**BRIDGEPORT WEST SEWER IMPROVEMENTS
SECTION C – LIFT STATION IMPROVEMENTS
CITY OF SIOUX CITY, IOWA
Project No. 6827C-539-201 – 2016**

ADDENDUM NO. 2

March 3, 2016

SHEET NO.
D.06

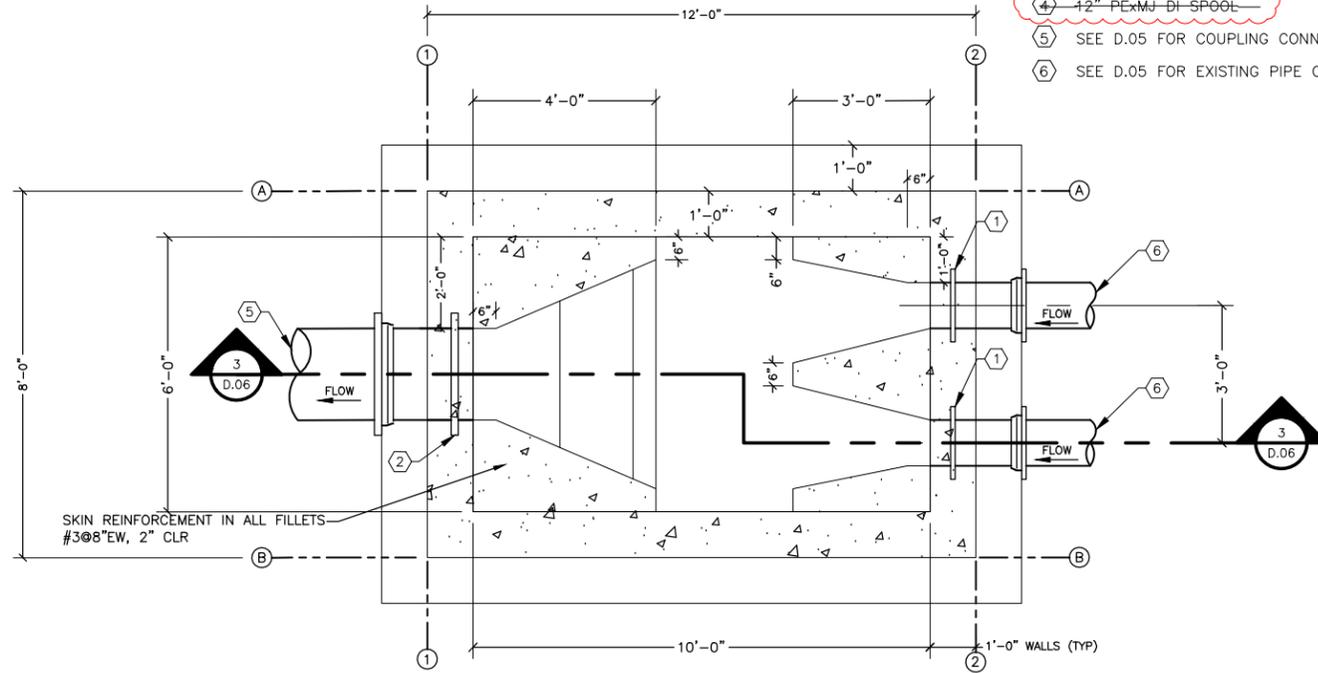
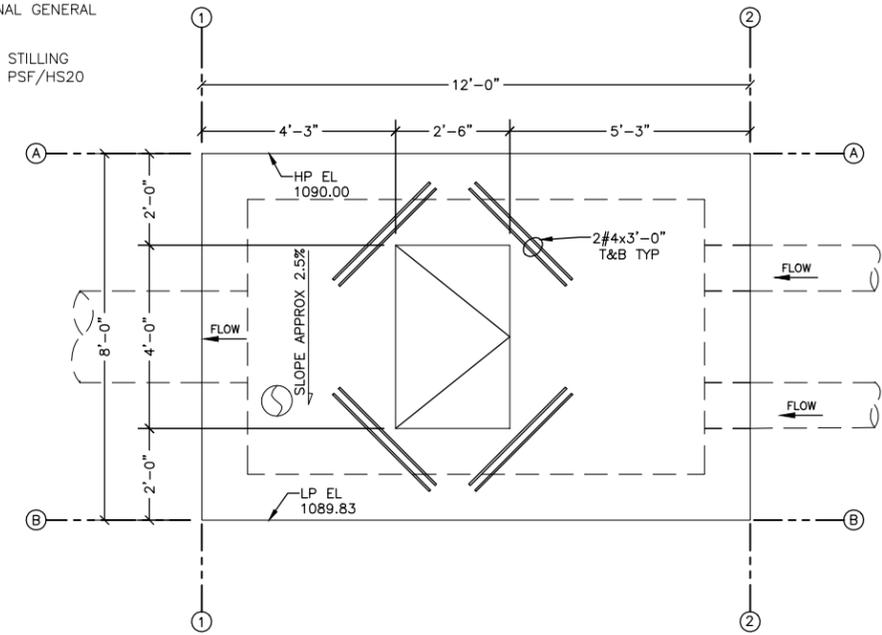
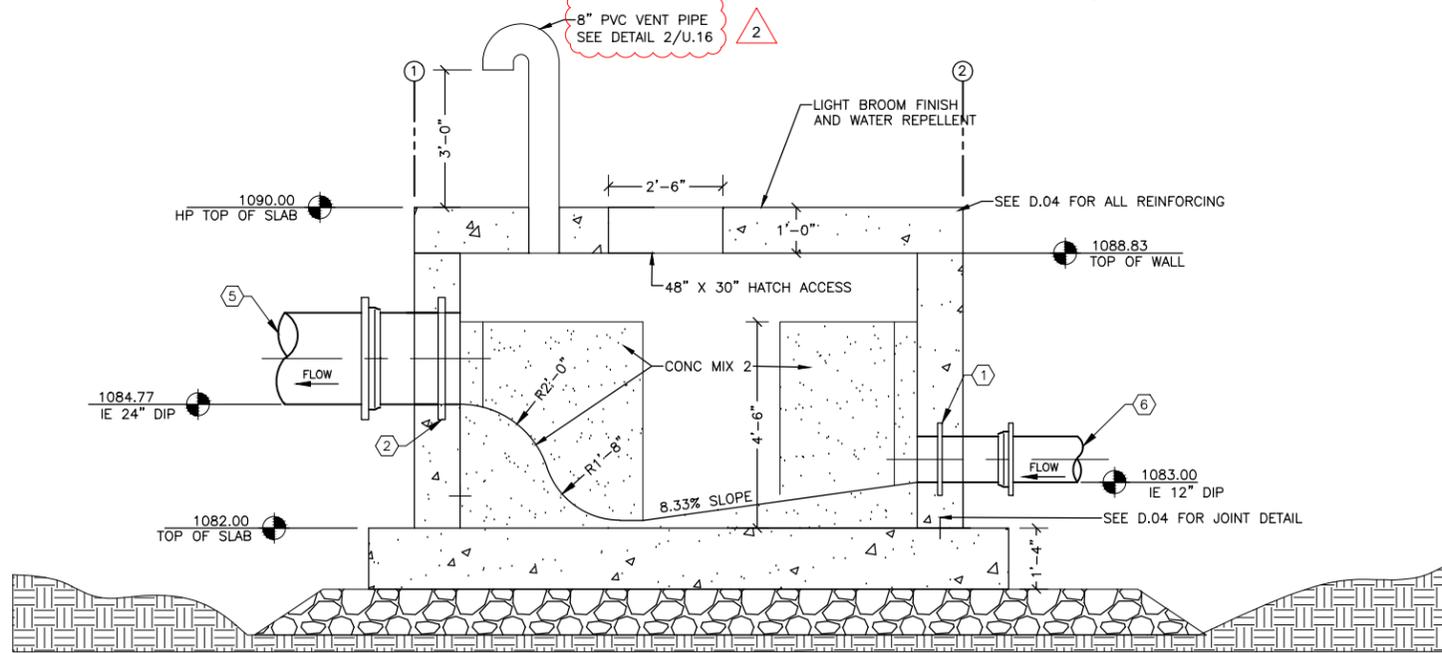
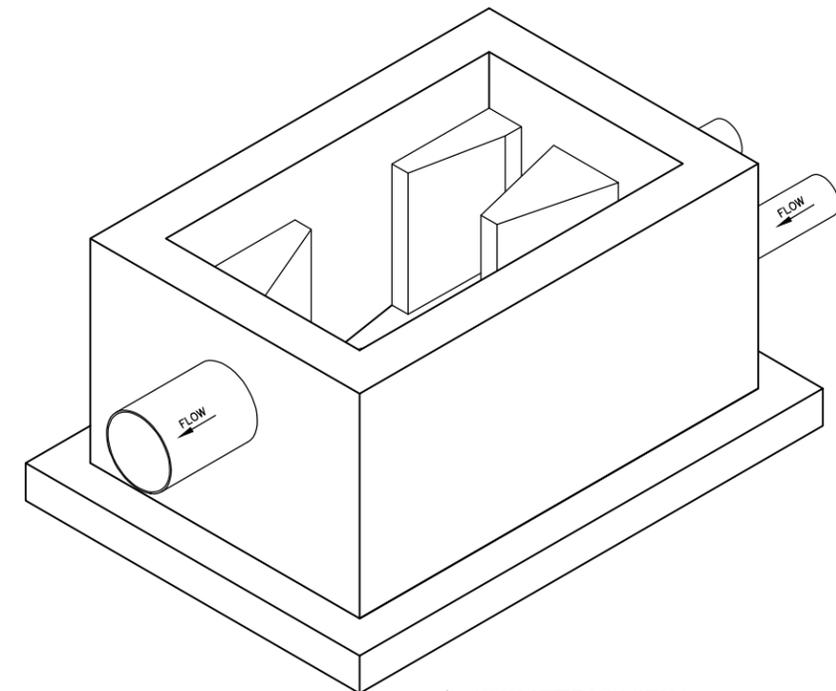
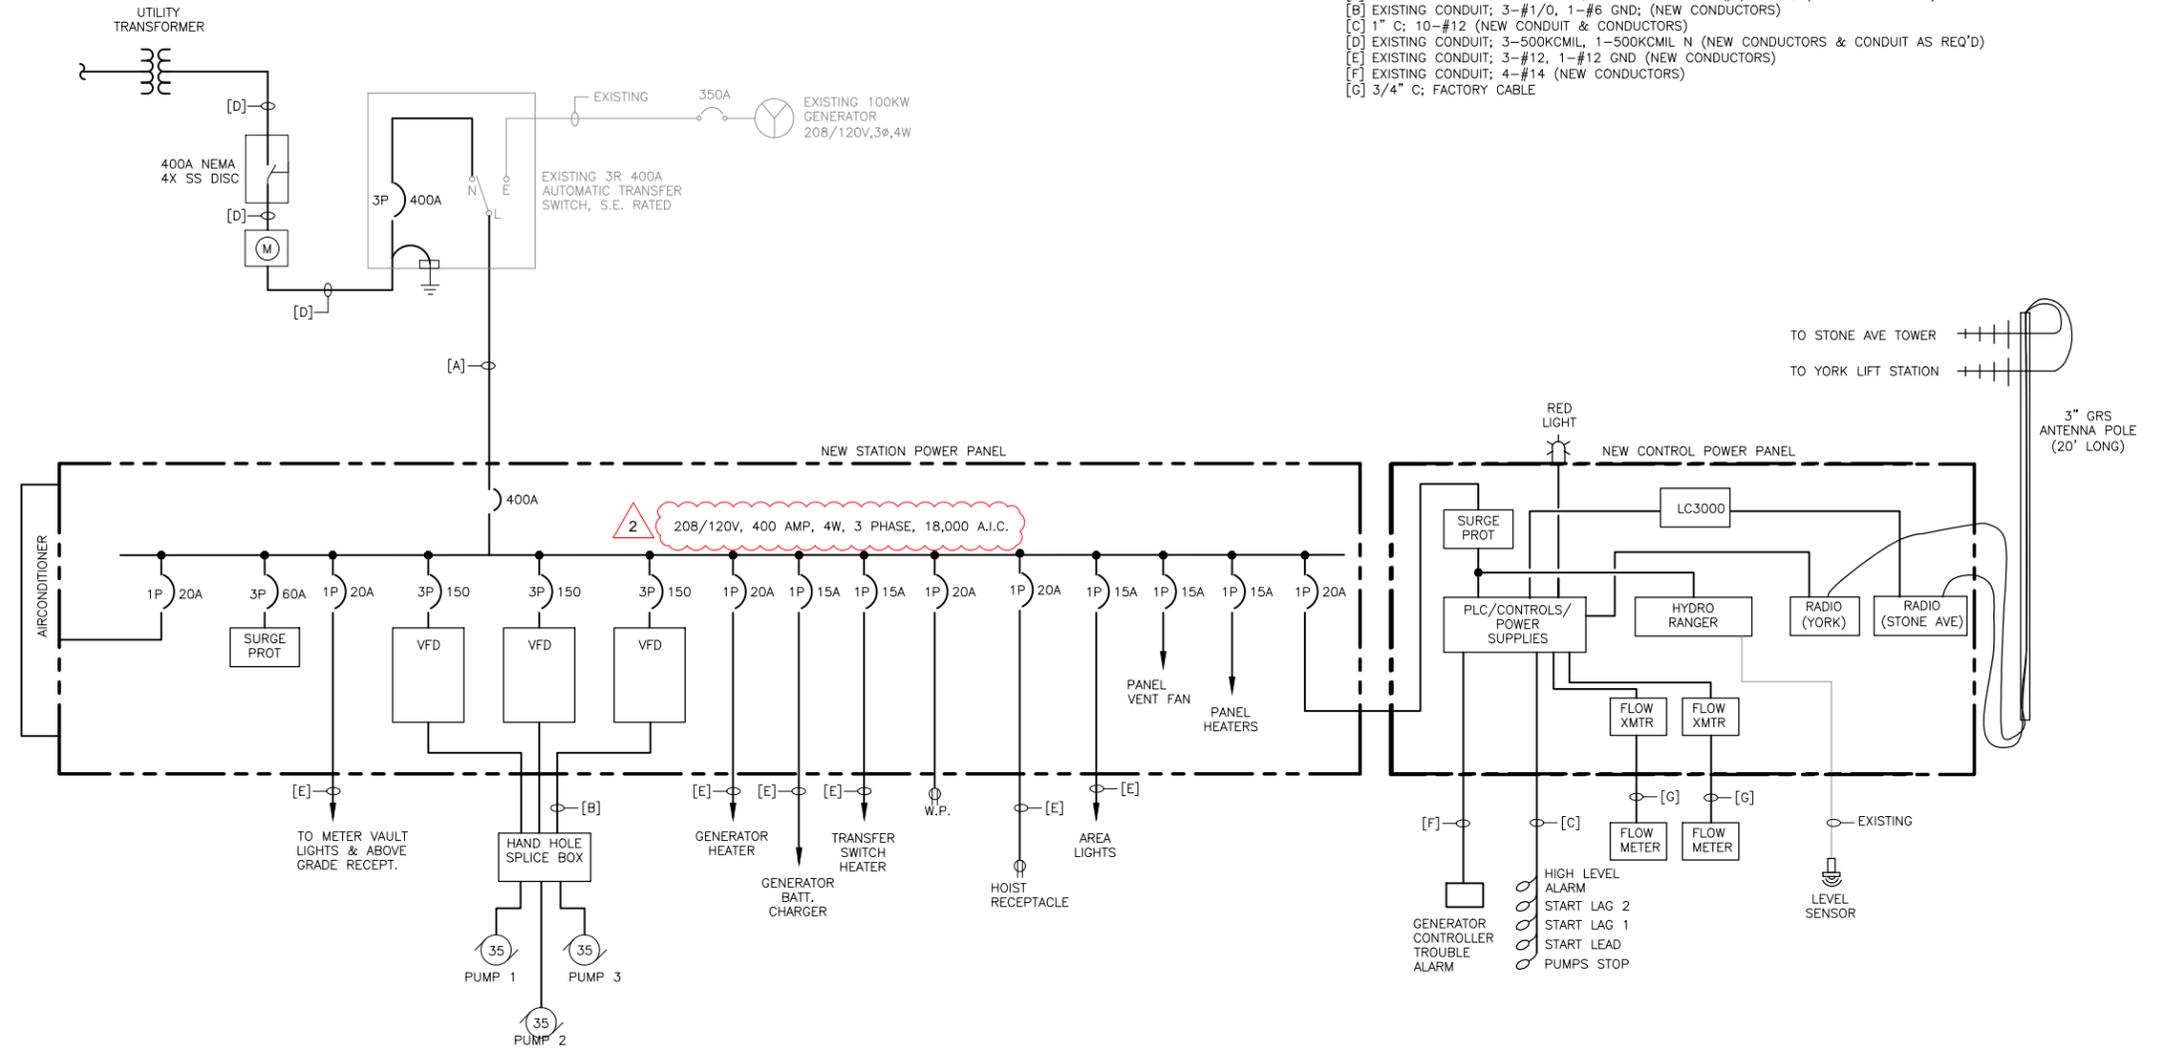
NO.	DATE	BY	REVISION DESCRIPTION
2	3/2/16	JV	REMOVE KEY NOTES 3 & 4, REVISE VENT PIPE NOTES

SHEET NO.
D.21

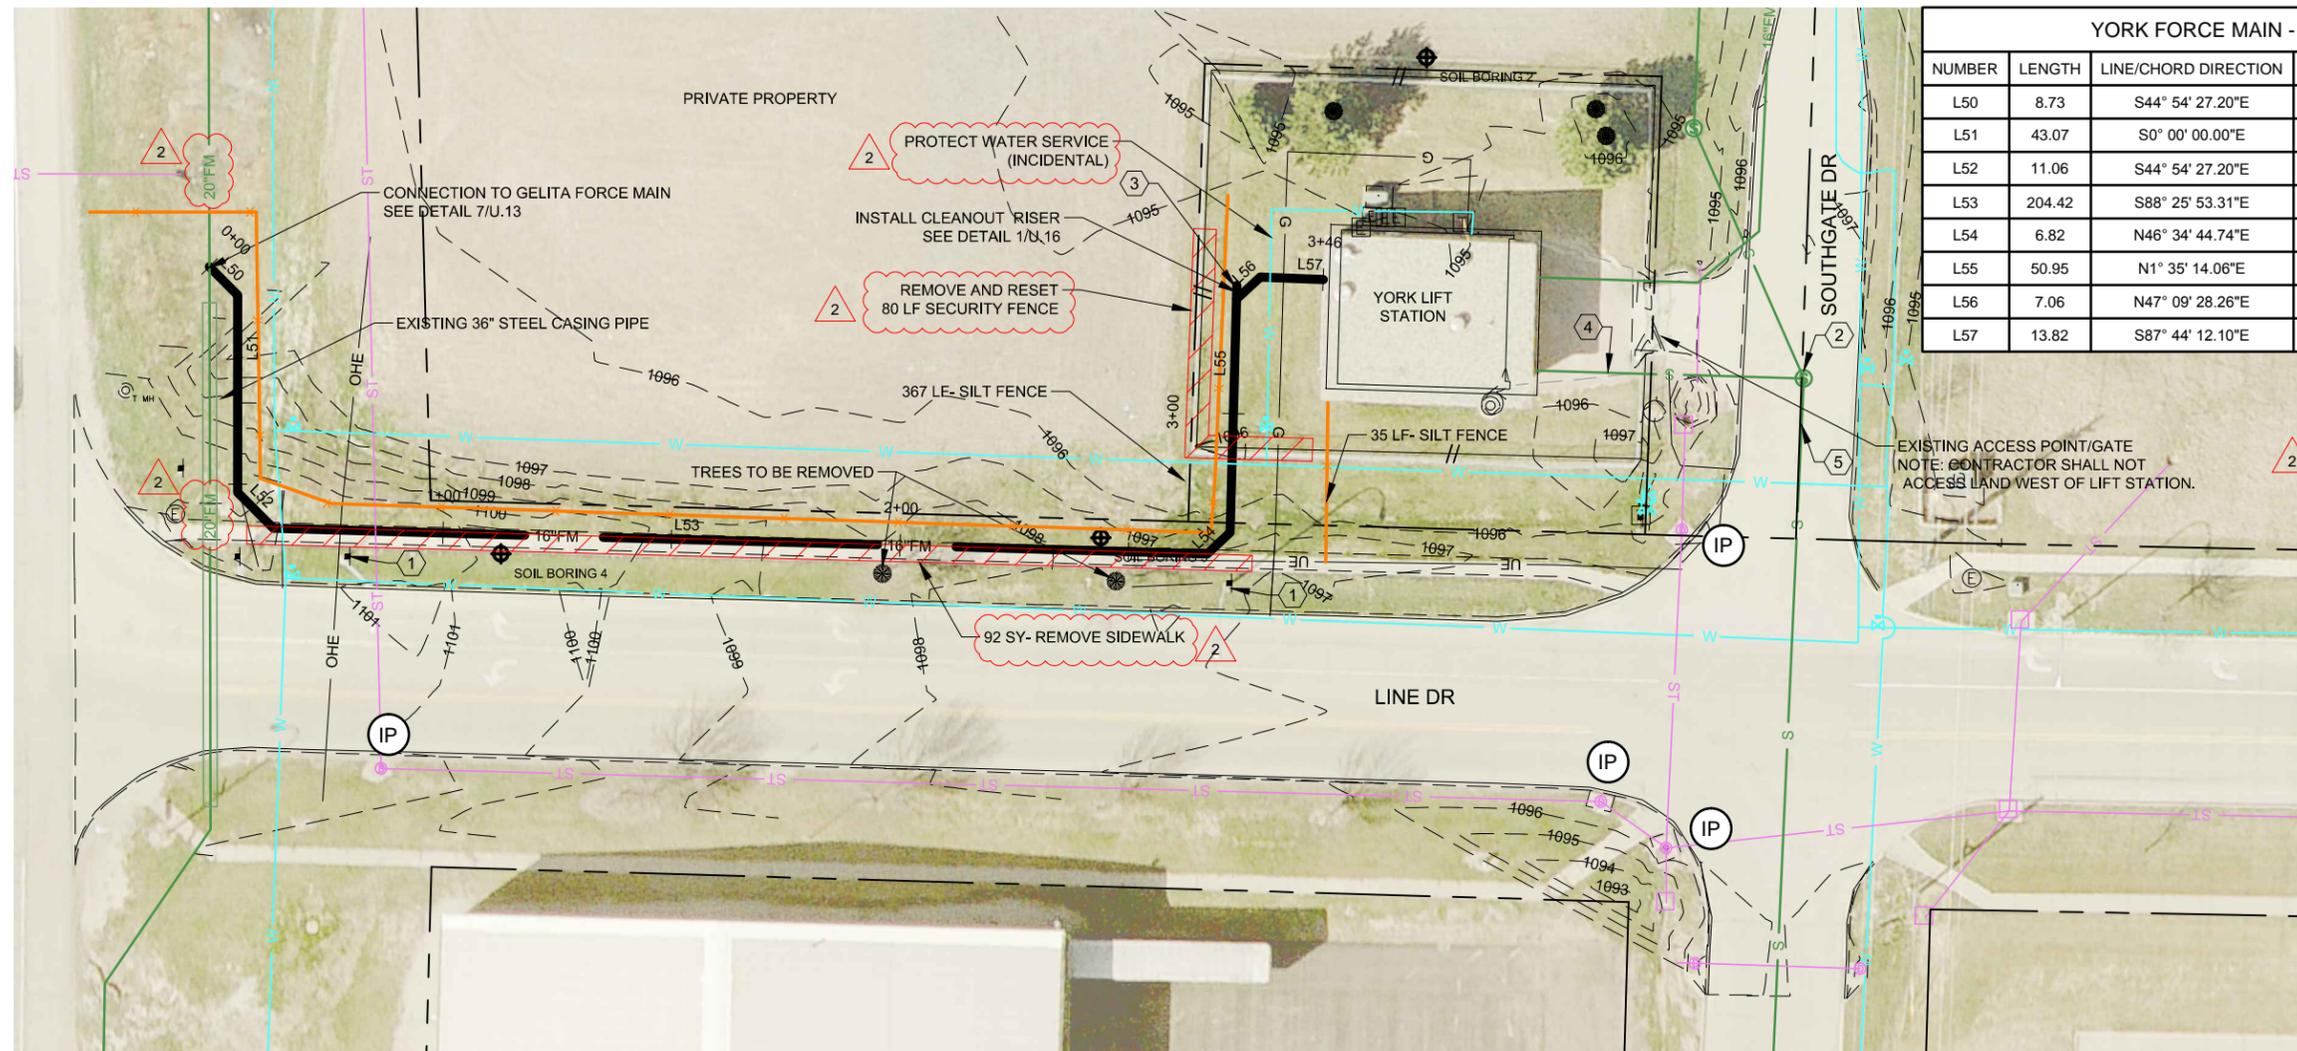
NO.	DATE	BY	REVISION DESCRIPTION
2	3/2/16	JV	REVISE POWER PANEL VOLTAGE
